10GBASE-KR Transmit Equalizer Tap Range and Resolution

LSI Logic

- **This presentation is related to LSI Logic comments on 10GBASE-KR transmit equalizer requirements.**
- **Investigate the impact of transmit equalization setting range and accuracy on link performance in terms of slicer SNR.**

Tap Weight Range

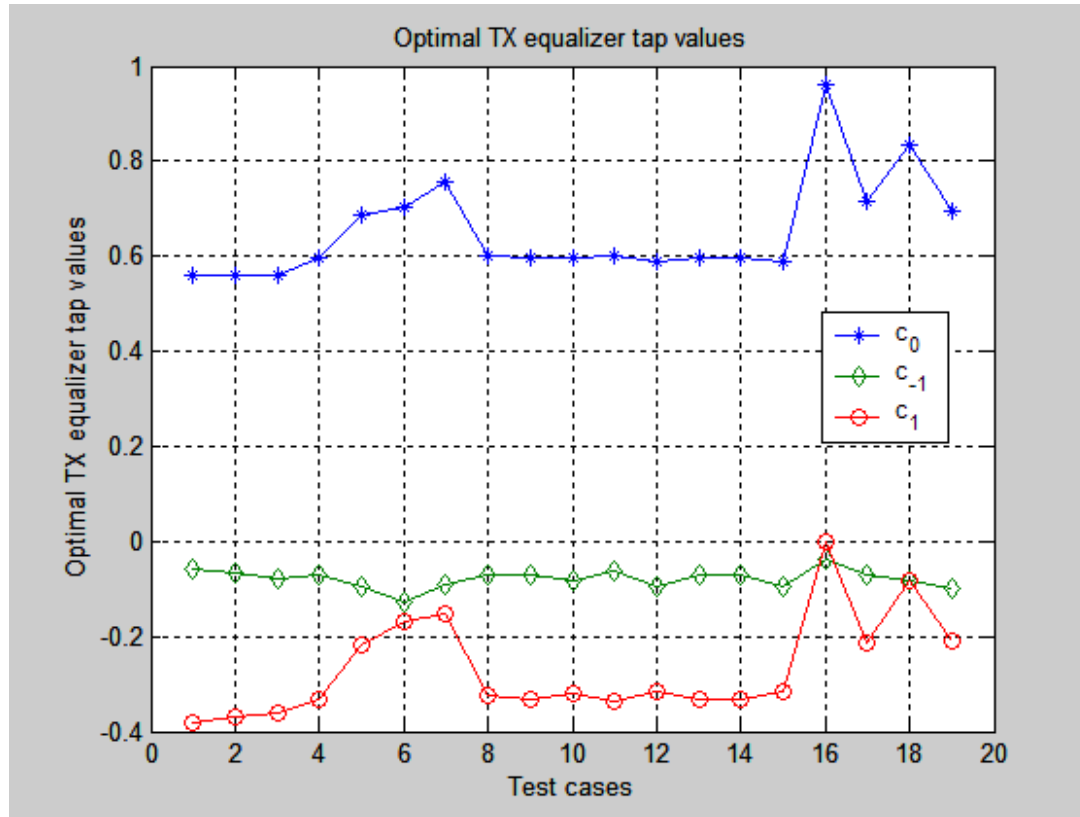
- Our simulation results show the required tap weight ranges are comparable to the current spec.
 - ◆ c_{-1} up to -0.175
 - ◆ c_1 up to -0.375

C_{-1} Tap Weight Resolution vs. SNR Degradation

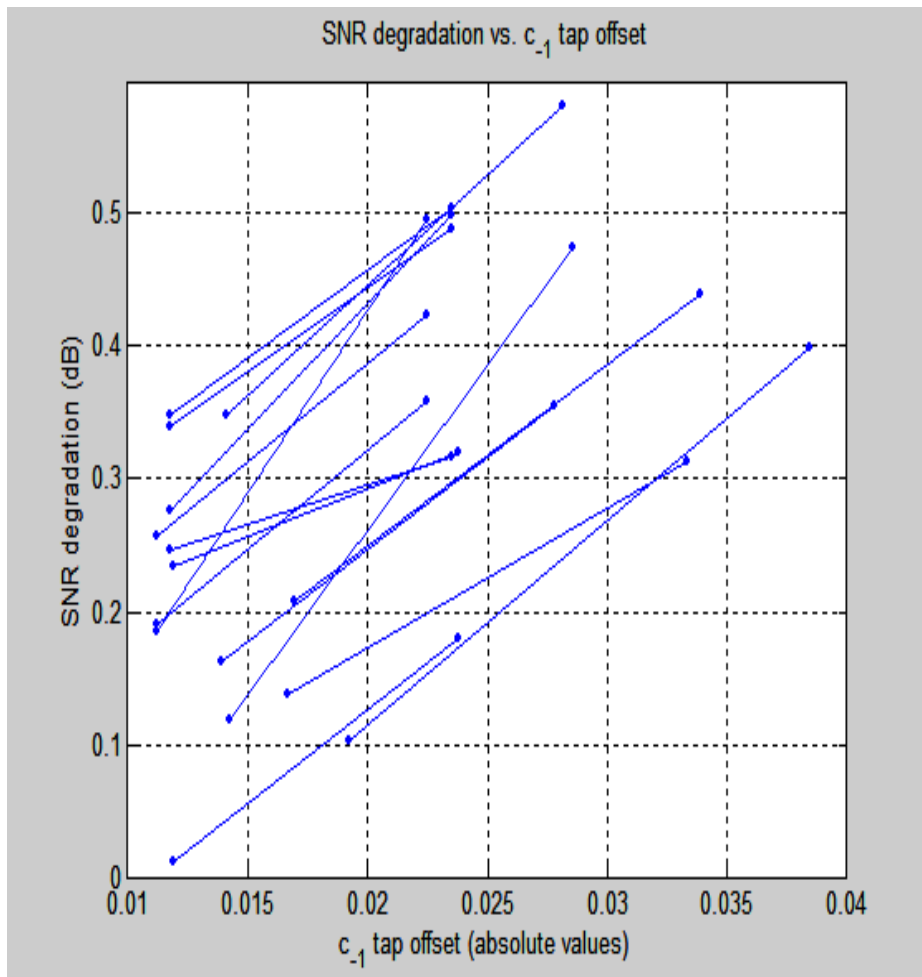
- **SNR performance is quite sensitive to C_{-1} tap resolution.**
 - ◆ **Reducing pre-cursor ISI mainly relies on C_{-1} tap.**
- **Minimum resolution of 0.025 is required.**

C_1 Tap Weight Resolution vs. SNR Degradation

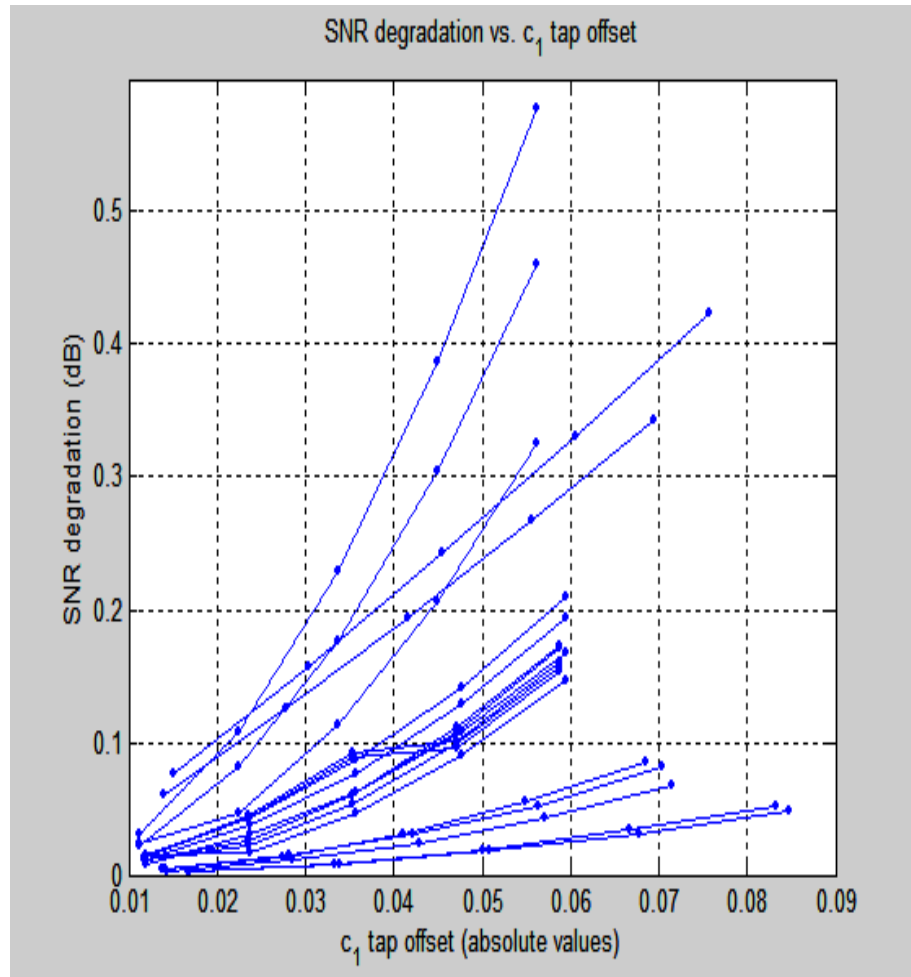
- Performance is not quite sensitive to C_1 as to C_{-1} .
 - ◆ The same amount of tap weight offset of C_1 only causes approximately half SNR degradation of C_{-1} .
- DFE at the receiver can further reduce post-cursor ISI.
- To get the same amount of performance accuracy, the step size of C_1 can be twice large of C_{-1} .
